ADDENDUM TO MAY 2019 CLEANUP PLAN

Former United Nuclear Corporation
Naval Products Facility
New Haven, Connecticut

April 27, 2020

BUILDING 6H WEST

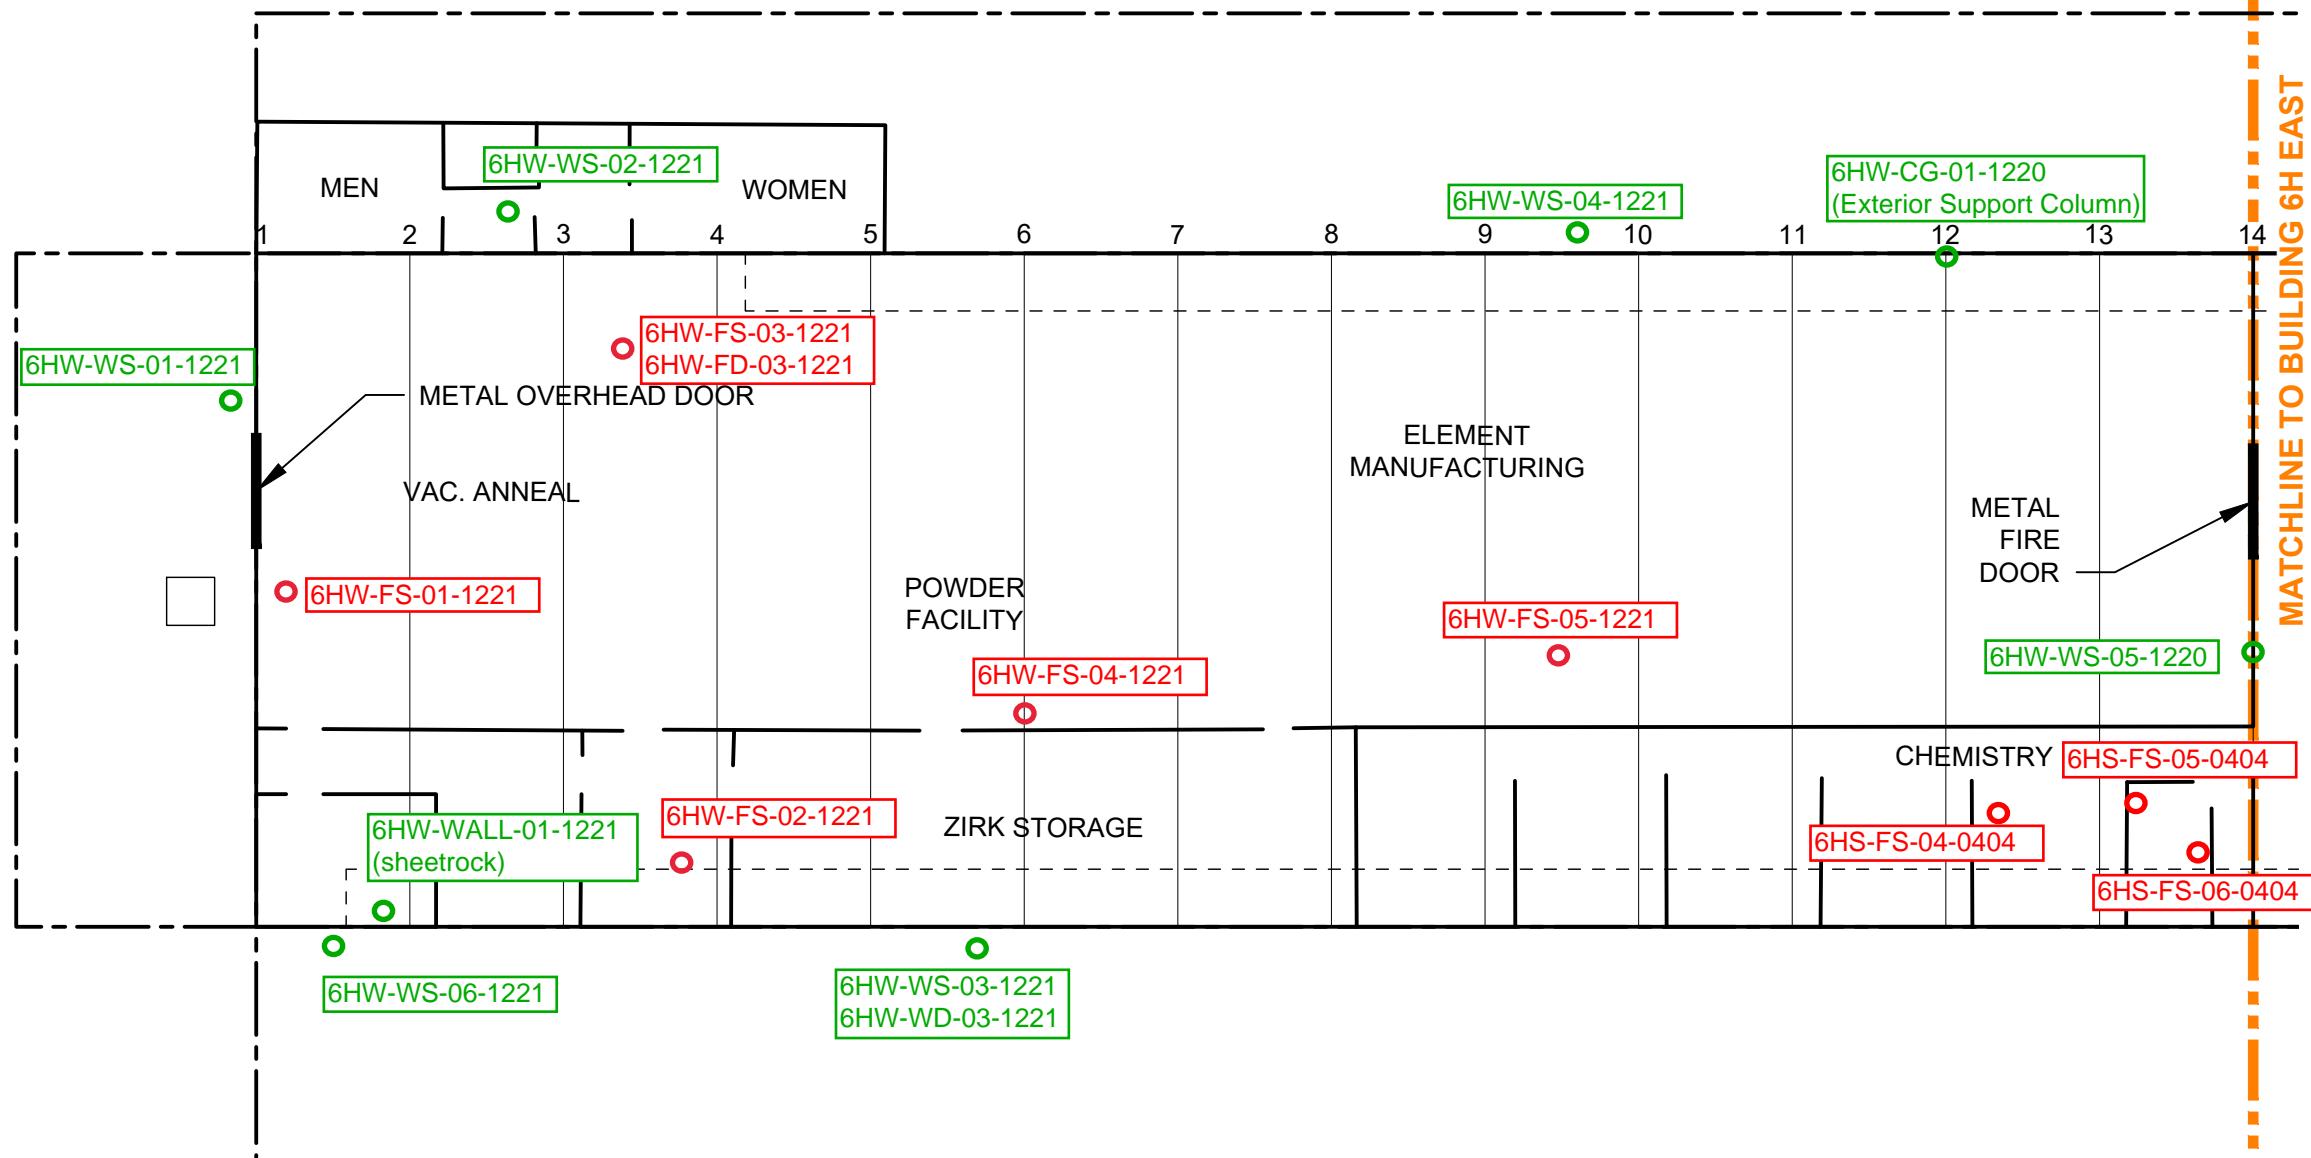
In response to a recent on-site audit comments provided by NRC, the figures and tables associated with May 2019 Cleanup Plan submittal have been revised so that all sampling nomenclature is consistent. The revised figures and tables are contained in Appendix A.
